SERVICE BULLETIN

M-1006

December 12, 1990

1991 ALTERNATOR ROTOR AND COMPENSATING SPROCKET SPACING

Alternator Rotor and Compensating Sprocket Assembly

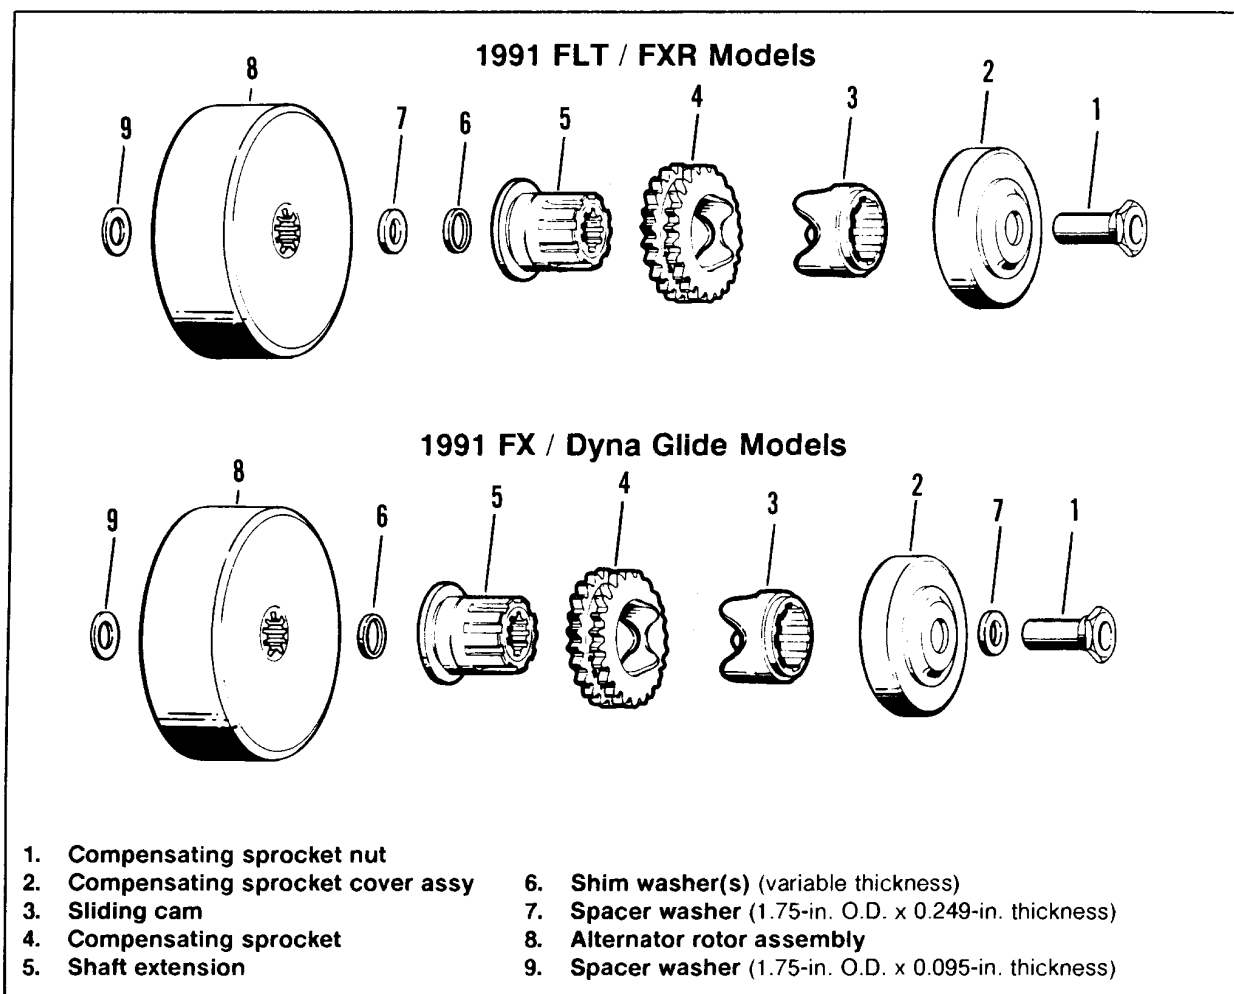
This Service Bulletin is being issued to inform Dealers about alternator rotor and compensating sprocket spacing on 1991 model year motorcycles with 1340cc Big Twin engines. The positioning of the spacer/shim washers on 1991 Big Twins will vary, depending upon the particular motorcycle model involved. In addition, the spacer/shim washers used on 1991 Big Twins are different, in size and/or positioning, than those used on earlier models. See illustration below.

All Big Twin models have a 1.75-in. O.D. x 0.095-in. thick spacer washer (9) immediately inboard of the alternator rotor assembly (8) on the sprocket shaft.

On 1991 FLT / FXR models, a 1.75-in. O.D. x 0.249-in. thick spacer washer (7) is positioned immediately outboard of the rotor, followed by a variable thickness shim washer(s) (6), and then the shaft extension (5).

On 1991 FX / Dyna Glide models, the variable thickness shim washer(s) (6) is positioned between the rotor and the shaft extension (5); the 1.75-in. O.D. x 0.249-in. thick spacer washer (7) is positioned between the compensating sprocket cover assembly (2) and the compensating sprocket nut (1).
